Ferry free E39 -Fjord crossings Bjørnafjorden

Document name:		
Verification Summary Report E39 Bjørnafjorden		
Document no.: SBJ-32-C5-DNV-6	62-RE-031	Pages: 42

# Verification Summary Report E39 Bjørnafjorden

Objective: Verification summary report showing the four-year work executed by DNV GL related to advisory, control and quality checking of documentation produced by designers for the E39 fjord-crossing project.

Figure 8-5 Phase 2 overview of concept plan and elevation

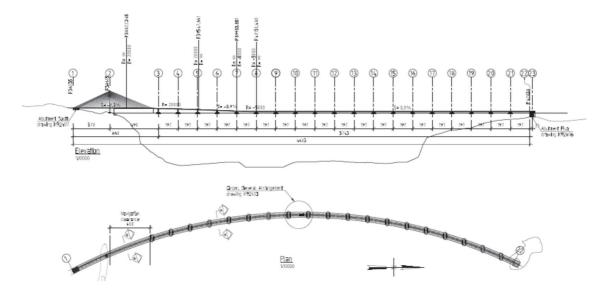
- It was recommended to establish an environmental (metocean) design specification that would be similar for the various concepts. This specification should be formulated such that it will provide conservative results for the ultimate strength design and for the fatigue design.
- The design should focus on the fatigue strength also in the conceptual stage.
- The representation of a Vierendeel girder with as a single beam model needs to account for the increased flexibility by adjusting the shear stiffness and also to consider the bending stresses caused by the Vierendeel bending moments.

• The method of applying combination factors between different stress-resultants to obtain design responses seems not satisfactory substantiated.

DNV GL independent calculations generally revealed smaller design load effects than designer's calculations. This difference was mainly attributed to differences in:

For the next design phases DNV GL recommended the designer to consider fatigue as well as other potentially onerous load combinations for ULS such as e.g. uneven wind field along the bridge girder.

Figure 8-7 Side anchored straight bridge

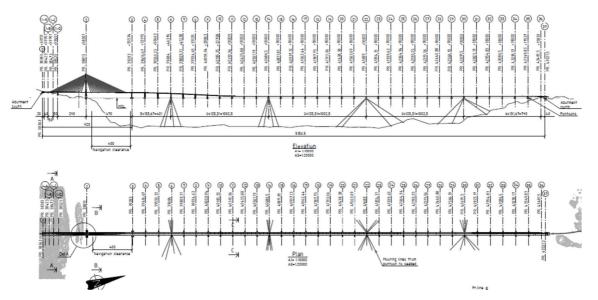
In report <u>SBJ-31-C3-DNV-62-RE-017-0</u>, several locations along the bridge were analyzed for traffic loading, both locally between pontoons and the localized effect of a wheel bending the plate and stiffeners between transverse frames. Typically, stress transfer factors between global load effects and stresses were established for 5 locations in several cross-section types. SCFs were established for 7 hot spots in the connection between stiffeners and a transverse frame for a section (F1). It was shown that for global loads the worst hot spot was the buttwelds in the bridge deck and bottom plate.

During the work with the stress transfer factors it was found that the F1-F3 type of cross sections were not fully effective against weak axis bending due to **shear lag** effect. This would increase the global stresses due to weak axis bending significantly. Thus, it was recommended to add longitudinal webs to obtain a cross section with neglectable shear lag effect.

Checks of the ultimate limit state shows exceedance of the criteria for large parts of the low bridge. This is mainly due to shear lag effects that make the cross-section less effective for weak axis bending.

It was found the stresses from weak axis bending could be reduced by a factor of up to 5.5 by introduction of three additional longitudinal webs. Also, the stiffness of the bridge about its weak axis were increased by the proposed modification.

Figure 8-8 AMC chosen alternative K12

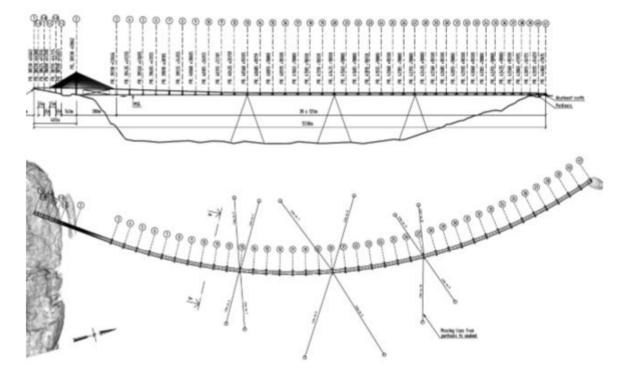
- Towing and installation of the complete floating bridge are complicated marine operations, and further planning is required.
- The locking system for the construction joints in the main bridge girder must be engaged quickly (i.e. within the weather window) during the installation of the main floating bridge, and thereafter be able to transfer the sectional bridge girder forces until the connections have been welded. The documentation regarding this is immature, and the locking system should be further developed.

- Local reinforcements and temporary steel are required to transfer loads during construction/assembly. Further detailing and to clarify possible consequences of remaining temporary steel on in-place (fatigue) stresses are recommended.

- It is recommended to further develop the metocean design basis for the next phase in the development of the BJF bridge. The analyses of the K12 concepts from AMC (and OON) have shown that the dynamic response in the bridge is sensitive to the current speed; a large current speed will reduce the response due to the increased damping. It is therefore necessary to define the current speeds and directions that shall be combined with extreme wind and wave conditions and also FLS conditions. For the FLS analyses it should also be specified how to combine wind sea and swell. Analyses so far by the designers and DNV GL have been performed without any wind load on the bridge girder in longitudinal direction. It should be investigated if this simplification is acceptable.

- The independent analyses carried out by DNV GL determines the contribution to fatigue damage from environmental loads in the bridge girder. The results from the screening analysis show a minimum calculated fatigue life of 482 years. This number should be reduced due to the local stress increase. A reduction similar could be expected that will bring the fatigue damage from environmental loads close to the required life of 250 years. The contributions to accumulated fatigue damage from traffic and tidal variation were not part of the independent analyses by DNV GL. The contributions will add to the damage only at certain details in the bridge. Tidal variation will only lead to fatigue damage close to the ends and traffic will predominantly give fatigue damage in the bridge deck. However, the fatigue loading as determined by DNV GL show that it should be expected that in certain areas details as assumed in the fatigue screening with SCF of 1.5 and SN-curve D may not be allowed even from environmental actions alone.

Figure 8-10 OON chosen alternative K12

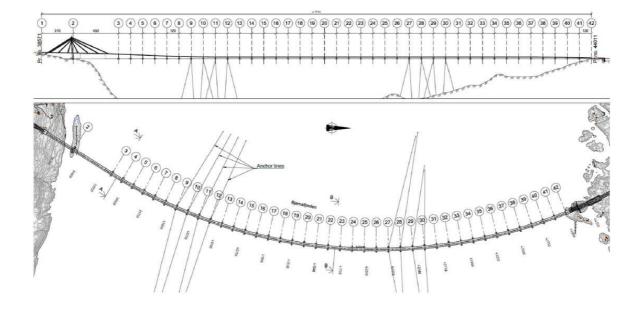
- Towing and installation of the complete floating bridge are complicated marine operations, and further planning is required.
- The locking system for the construction joints in the main bridge girder must be engaged quickly (i.e. within the weather window) during the installation of the main floating bridge, but the documentation regarding this is immature. The locking system should be further developed.

- Local reinforcements and temporary steel are required to transfer loads during construction / assembly. Further detailing and to clarify possible consequences of remaining temporary steel on in-place (fatigue) stresses are recommended.

- It is recommended to further develop the metocean design basis for the next phase in the development of the BJF bridge. The analyses of the K12 concepts from OON (and AMC) have shown that the dynamic response in the bridge is sensitive to the current speed; a

- The independent fatigue analyses carried out by DNV GL determine the contribution to damage from environmental loads in the bridge girder. The results from the screening analysis show a minimum fatigue life of 148 years. This number should be reduced with the local stress increase. A reduction similar to the example given in the report could be expected that will bring the fatigue damage from environmental loads significantly below the required life of 250 years. The contributions from traffic and tidal variation were not part of the independent analyses by DNV GL. The damages will add only at certain details in the bridge. Tidal variation will only lead to damage close to the ends and traffic will predominantly give damage in the bridge deck. However, the fatigue loading as determined by DNV GL seems to be above the required capacity for large part of the structure.

- In regard the mooring system, the size of the bottom chain needs to be increased and this can be included at a small cost increase. Thereby, the strength of the polyester lines will become governing with a safety factor just above the requirement. The fatigue in the bottom chain is below the requirement, but this will be changed if the dimension of the bottom chain is increased due to the strength requirement. The increased dynamic loads in mooring lines may also affect the out-of-plane bending of the top chain. This should be further evaluated.

- The designer has used quasi-static stiffness for the mooring lines, while DNV GL has used dynamic stiffness, which is more appropriate. This results in larger dynamic line tensions than the designer. Apart from the small effect on the eigen periods, the use of quasi-static stiffness is probably slightly conservative with respect to the response in the girder. Otherwise, the analysis results are generally in line with designer's results.
